**Remediation System Evaluation (RSE)**  
**Moss-American Superfund Site**  
**Milwaukee, Wisconsin**

# REMEDIATION SYSTEM EVALUATION MOSS-AMERICAN SUPERFUND SITE MILWAUKEE, WISCONSIN

Final Report  
March 2011

Prepared for:  
US Environmental Protection Agency  
Region 5

Figure 2. Proposed Additional Monitoring Locations for Chemical Analysis

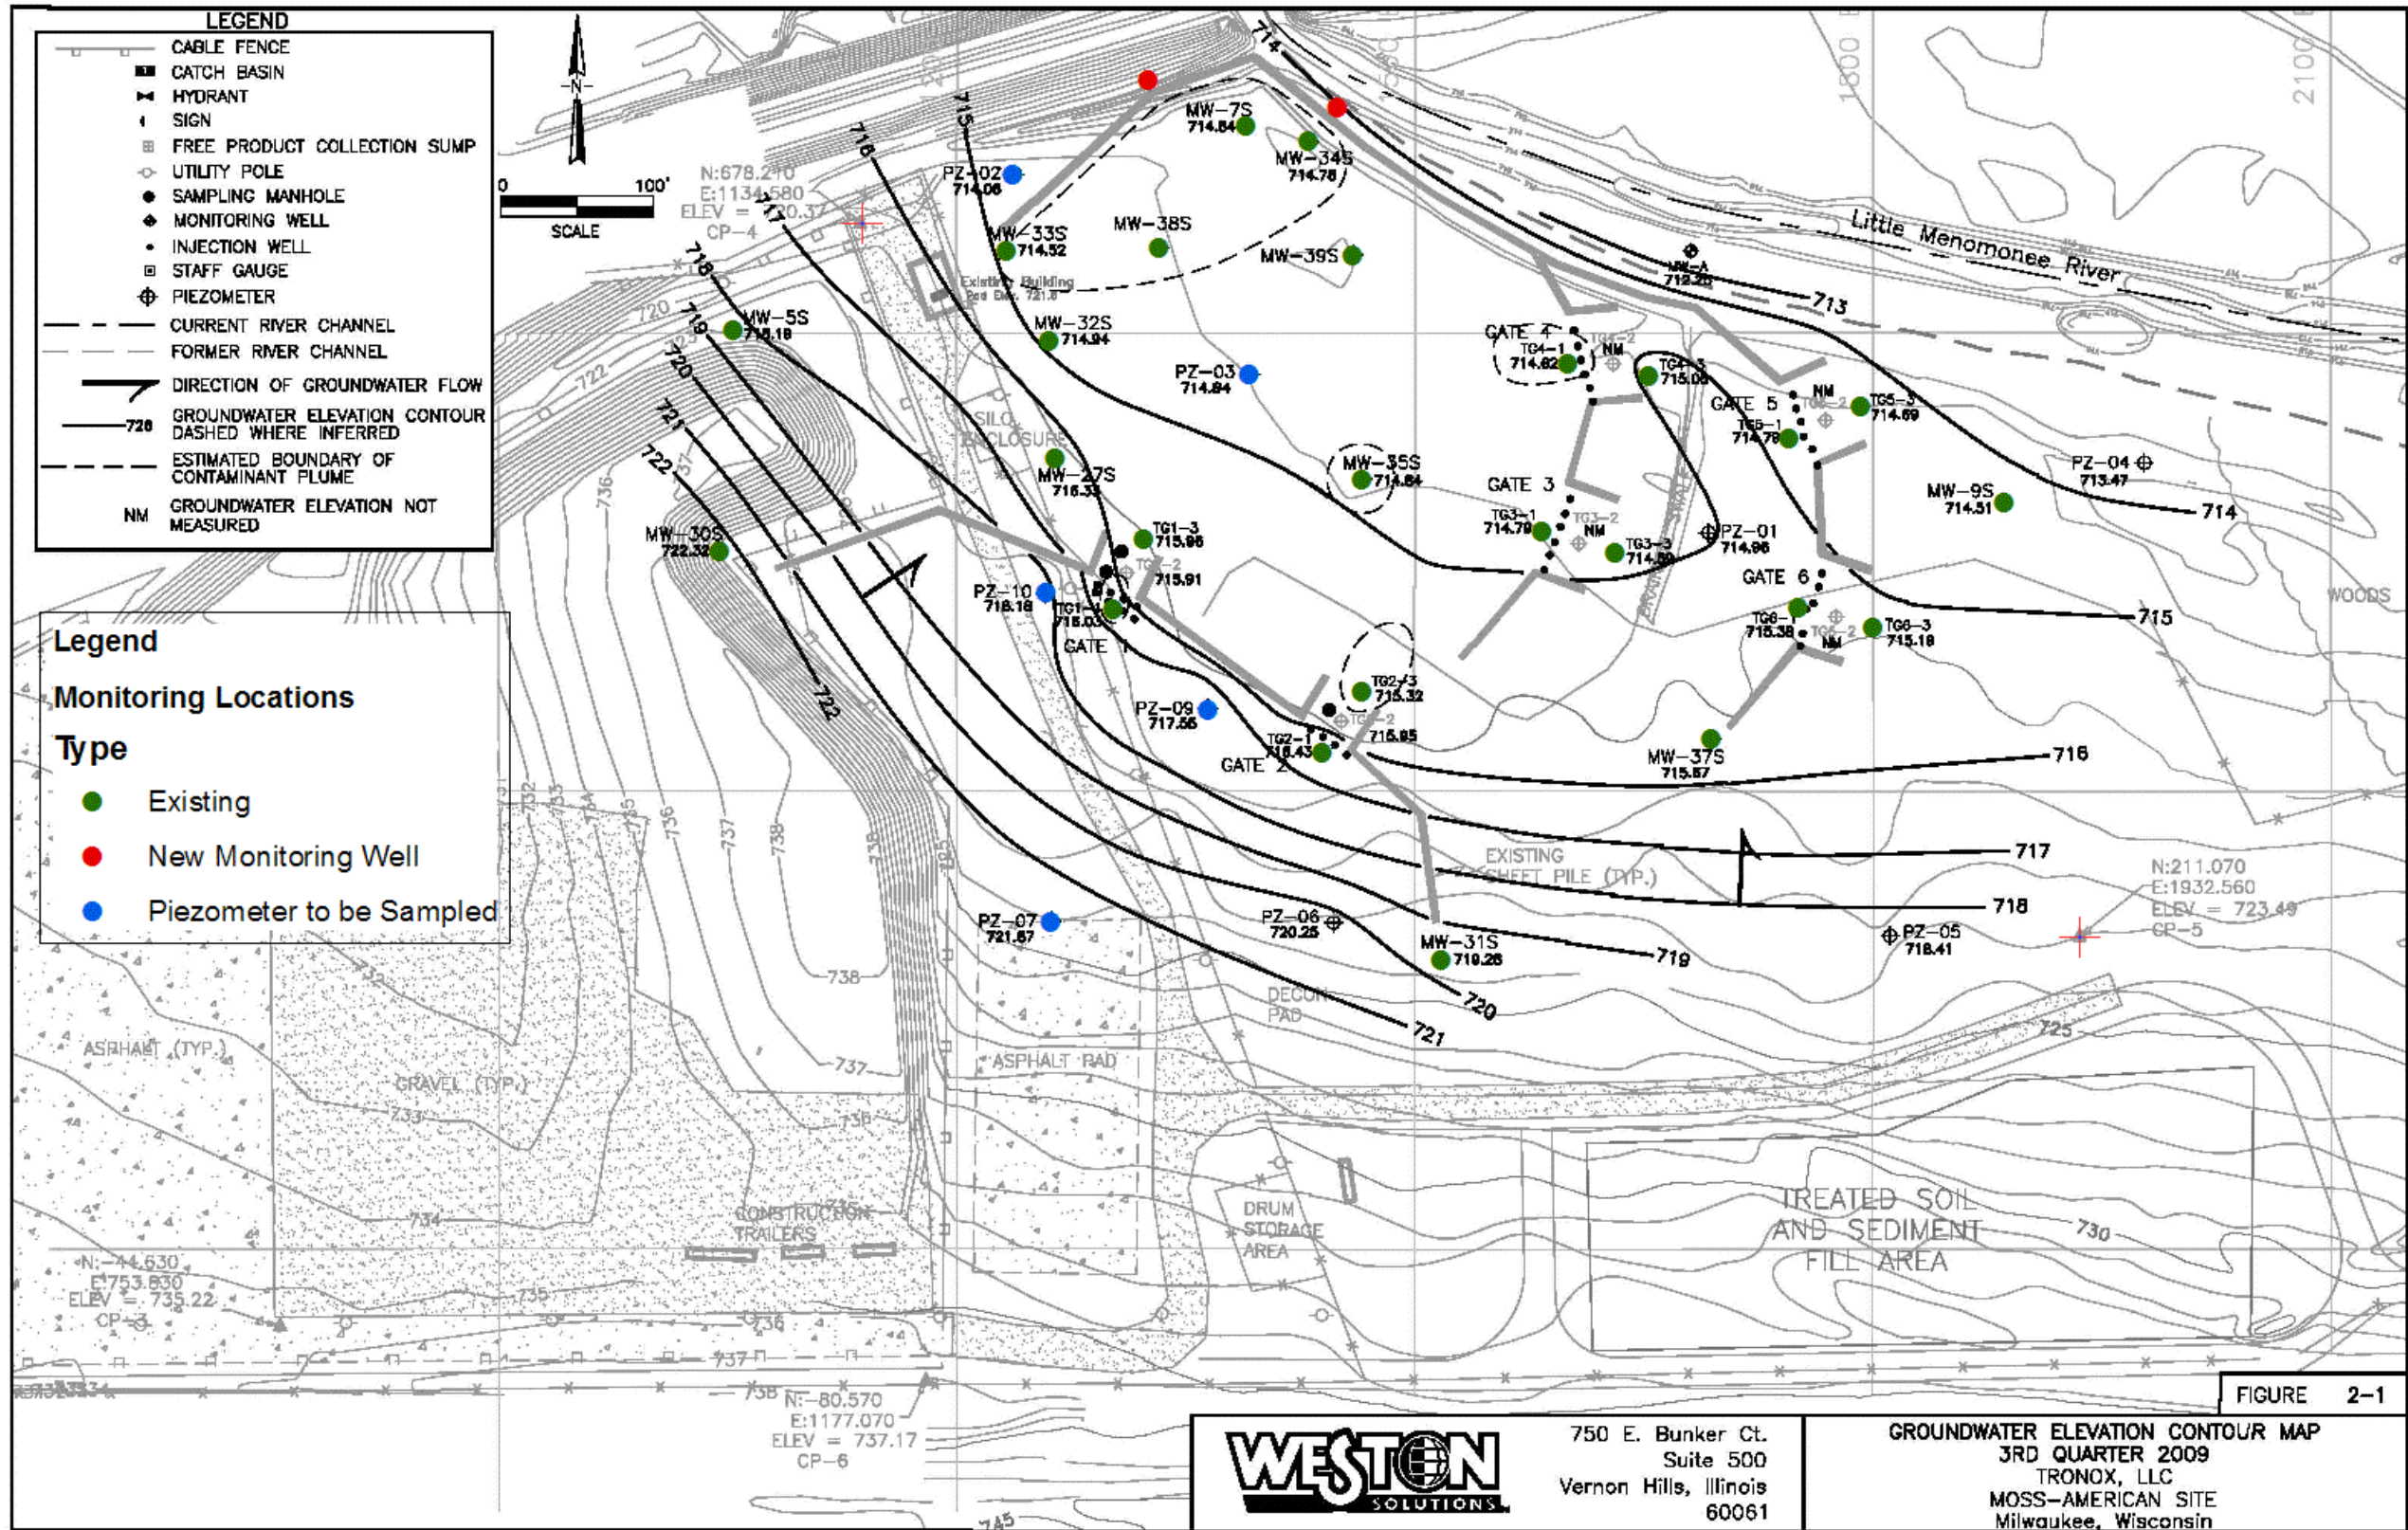
The primary areas of concern for the monitoring program are the lack of chemical data outside the sheet pile wall near MW-7S and MW-34S, where there is a possibility that contaminants could be passing through the joints or migrating around the end of the wall, and the extent of remaining contamination near TG1-1. A secondary area of concern is the extent of the dissolved-phase plume in the interior of the funnel and gate system. The following enhancements to the monitoring program are recommended (see Figure 2 for well locations):

- Install two monitoring wells outside the sheet pile wall to the north of MW-34S and to the west of MW-7S to determine if contaminants are migrating through the sheet pile wall.
- Develop and sample piezometer PZ-02 to determine if contaminants are migrating around the end of the sheet pile wall.
- Develop and sample piezometers PZ-07, -09, and -10 to determine the up-gradient extent of remaining contamination near TG1-1.
- Develop and sample piezometer PZ-03 to confirm the extent of the dissolved-phase plume in the interior of the funnel and gate system.
- Survey MW-38S and MW-39S and include water levels from these wells in groundwater flow maps.

Figure 3. Potential NAPL Investigation Program

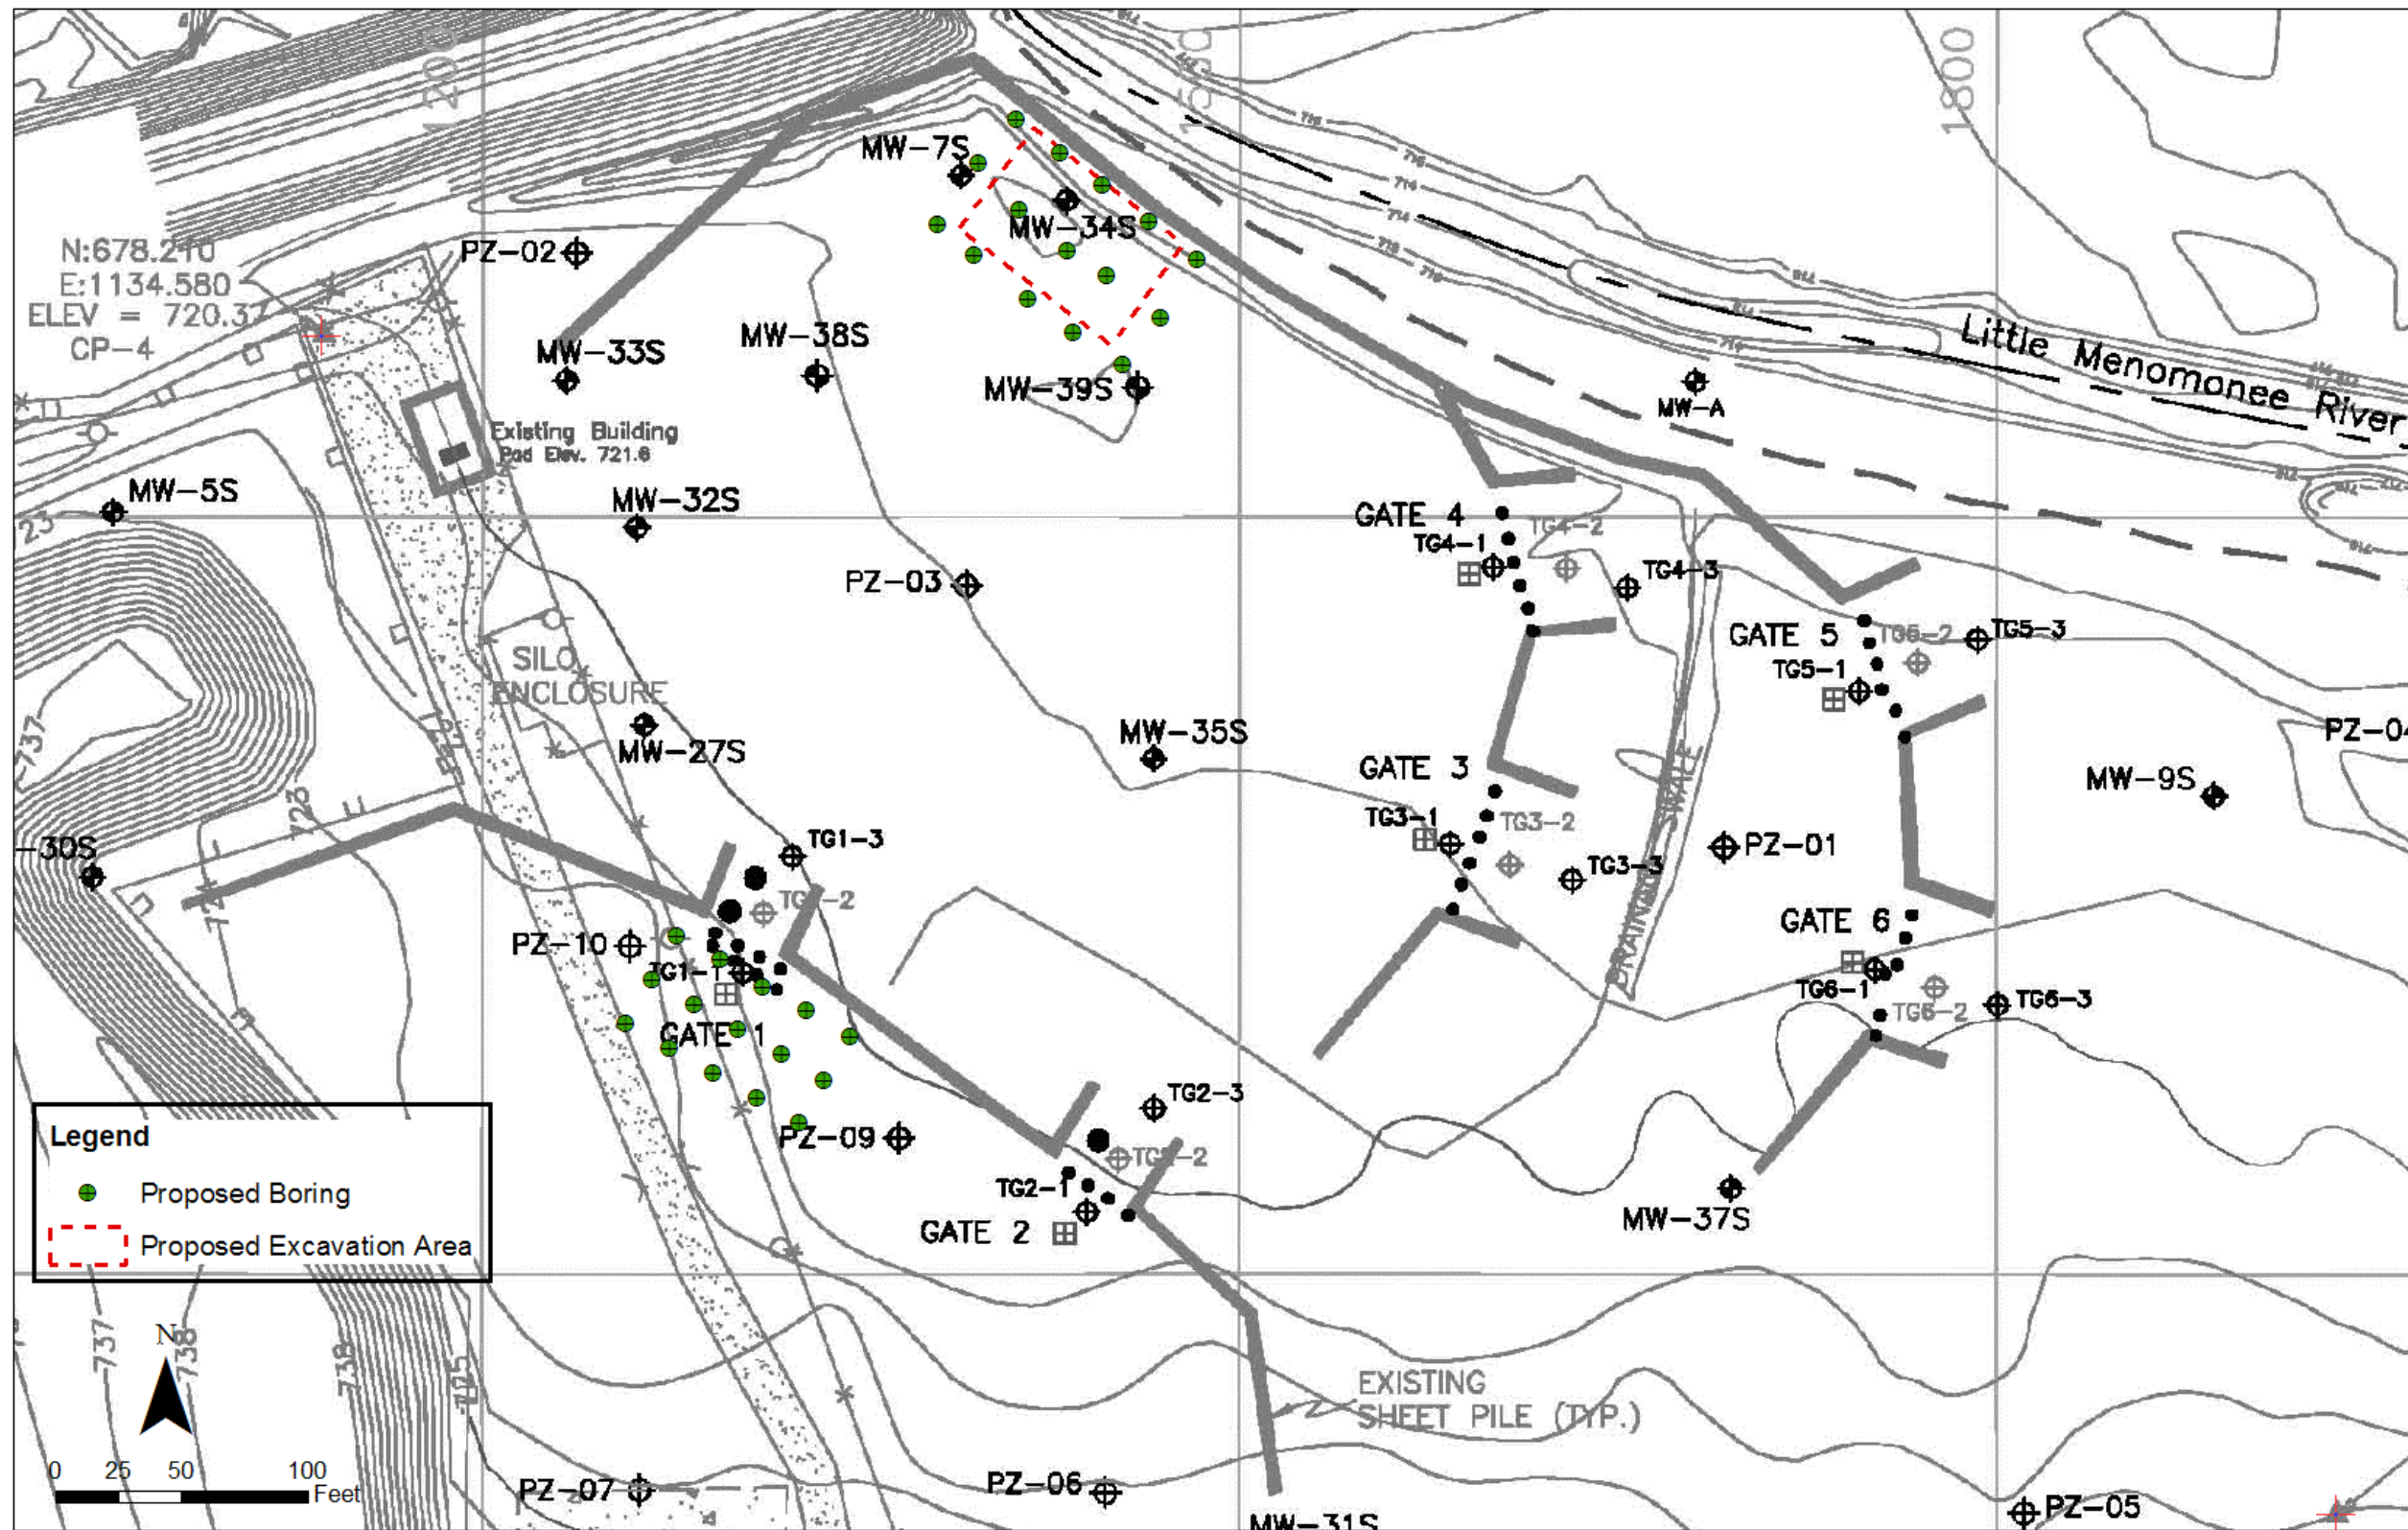
naphthalene concentrations approaching 9,100 µg/L<sup>1</sup> would indicate NAPL presence in the vicinity of the soil boring. A schematic of a potential NAPL investigation program is provided on Figure 3. Locations where NAPL presence, soil concentrations or groundwater naphthalene concentrations greater than 9,100 µg/L were detected would be considered for inclusion in an excavation footprint. This investigation for each area would cost an estimated **\$36,000** based on assumptions described in Table 3.

Figure A-3. Current Conditions

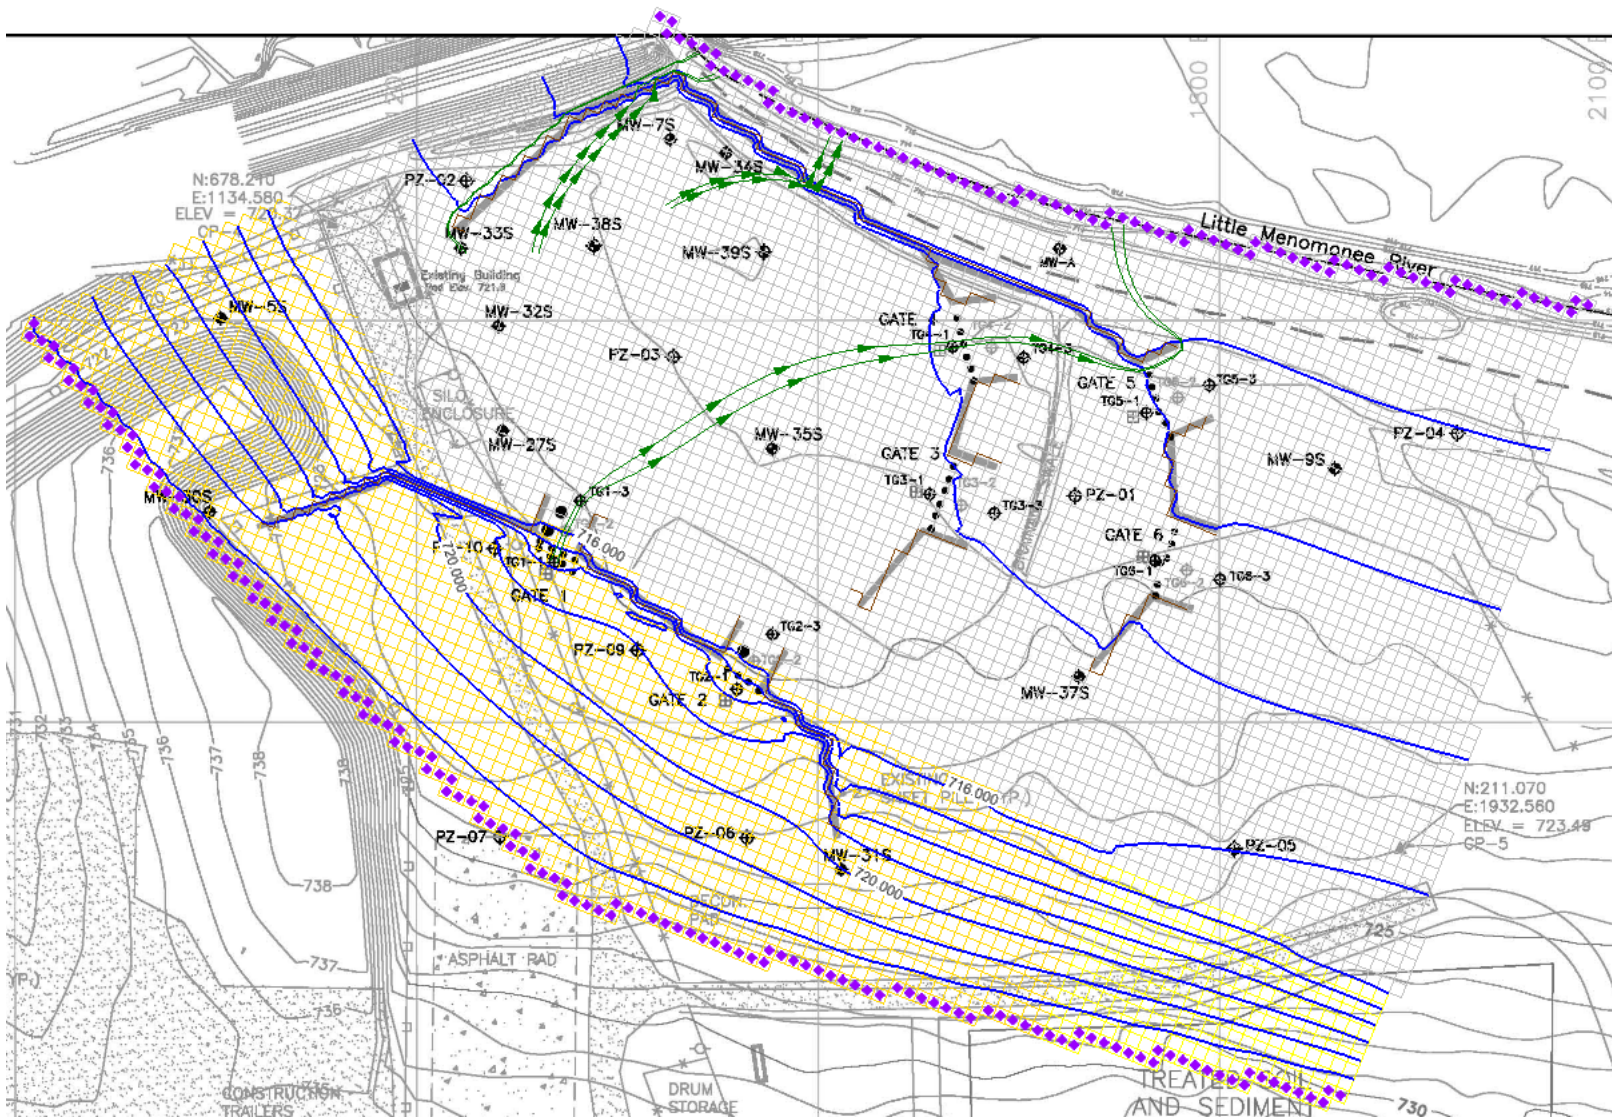
Figure A-3 shows the groundwater elevation contours for the current funnel and gate configuration. The model shows that there is a stagnation point area near MW-7S and MW-34S as indicated by the slow particles moving through the sheet pile wall and that groundwater near MW-33S may be moving around the end of the sheet pile wall. Particles generated at Gate 1 are shown to migrate toward the eastern gates indicating that this part of the flow system is functioning as intended.
